**ADDENDUM NO. 2
TO THE BID DOCUMENTS**

Project: Homer Fire Station #2 – Skyline Drive
Addendum Issue Date: February 21, 2014 (Friday)
Bid Date: **February 27, 2014 @ 2:00PM (Thursday)**
Previous Addenda Issued: One (1)
Issued By: Dan Nelsen
Public Works Project Manager
City of Homer
Homer, AK 99603
dnelsen@ci.homer.ak.us

A **DEMOLITION PLAN**
 SCALE: 1/4"=1'-0" (22x34) / 1/8"=1'-0" (11x17)

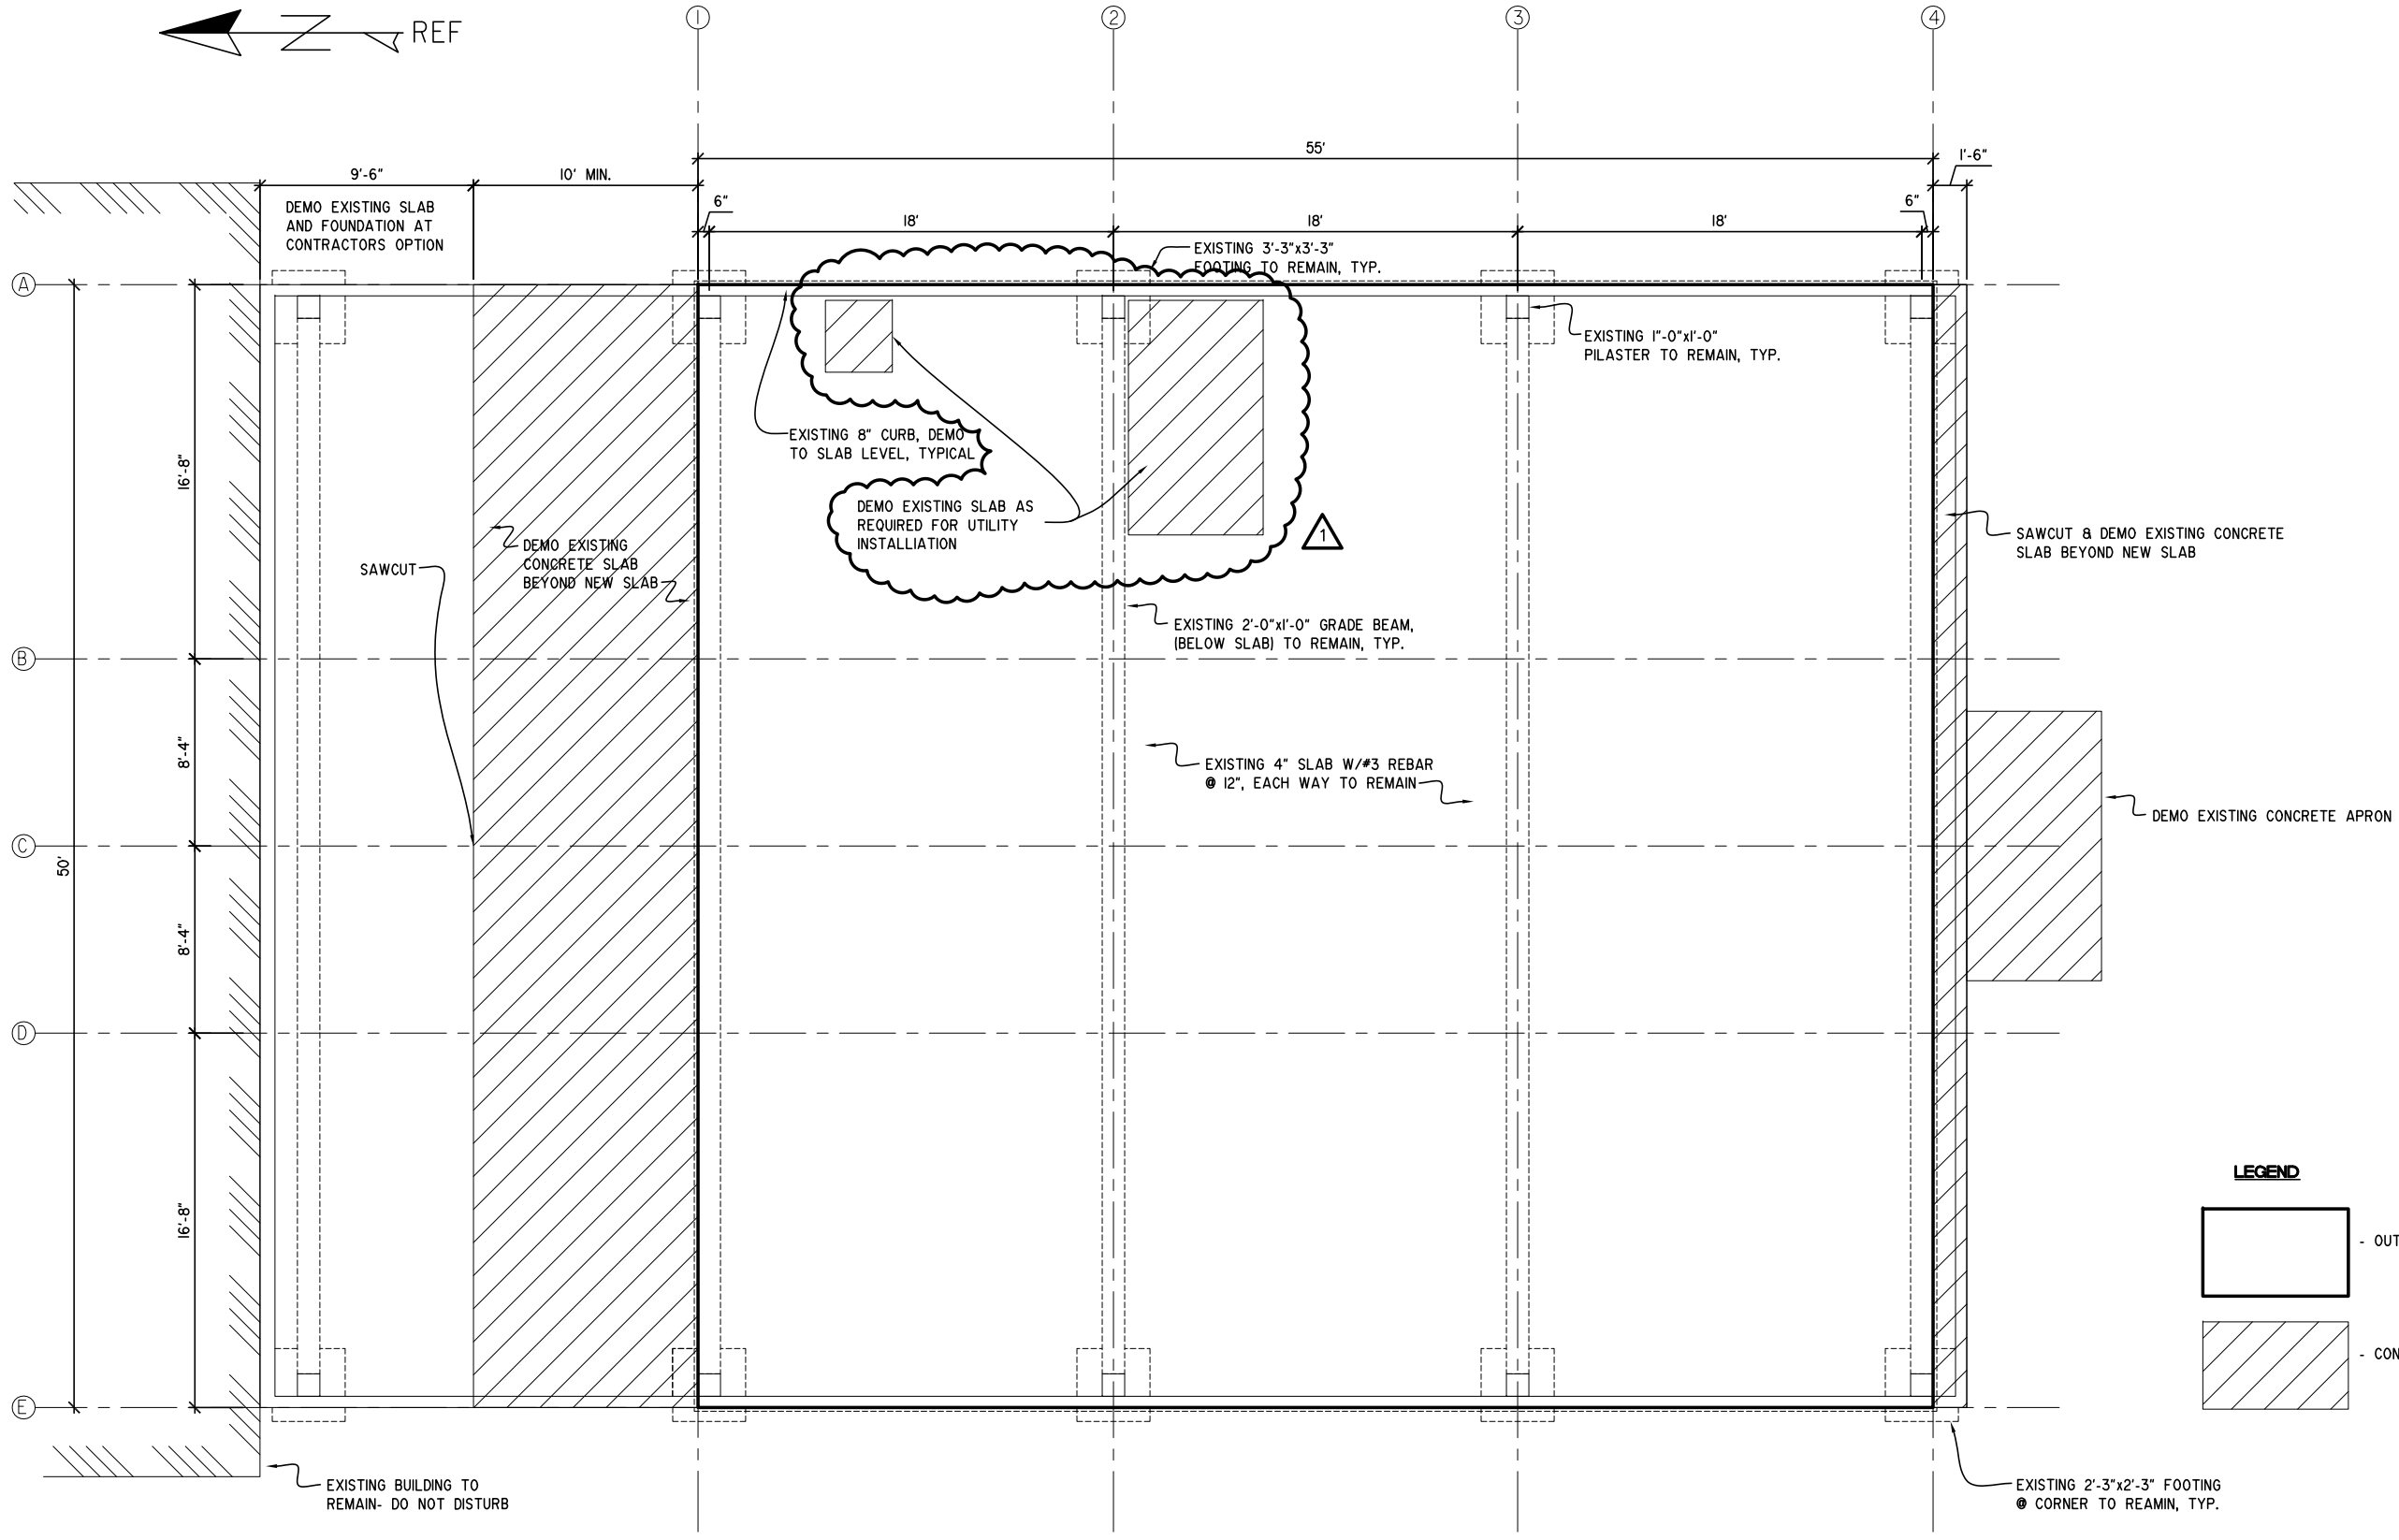
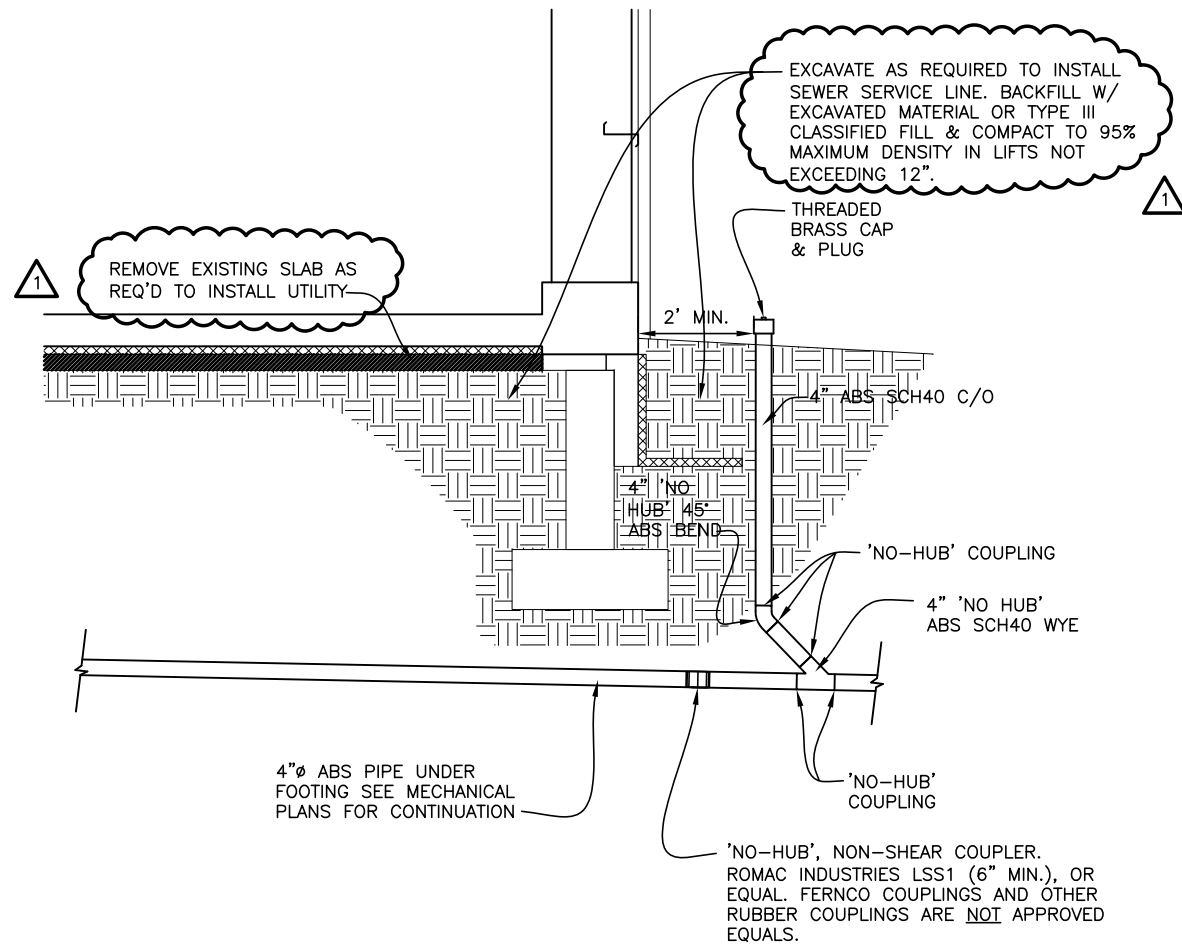
ITEM 2 - On plan sheets C1 and C6 a 5’ wide section of existing concrete slab is shown for removal, then on plan sheet S1.4 it lists 10’ min to be removed. Please advise on the correct are to be removed.

ITEM 11 - How does the sewer connect to the new Fire Station building? Will the Contractor need to cut, remove, and replace the existing concrete slab as necessary for this connection and for all floor drains and interior sewer?

Answer: Demolition of a 10’ wide section of existing concrete slab is intended on the North side of the building. Update note on C1 and Detail A/C4 and to read “Remove 10’ wide section of slab per detail F/C6”. Grade new gravel fill on North Side of Building as shown in Sheet C3 revision #1 and Detail F/C6 revision #1.

Answer: Contractor will need to cut and remove existing concrete slab as required to install floor drains and plumbing. Contractor will need to backfill and compact disturbed soils. Replacing existing concrete slab is not required. See updated sheets C7 and S1.4.
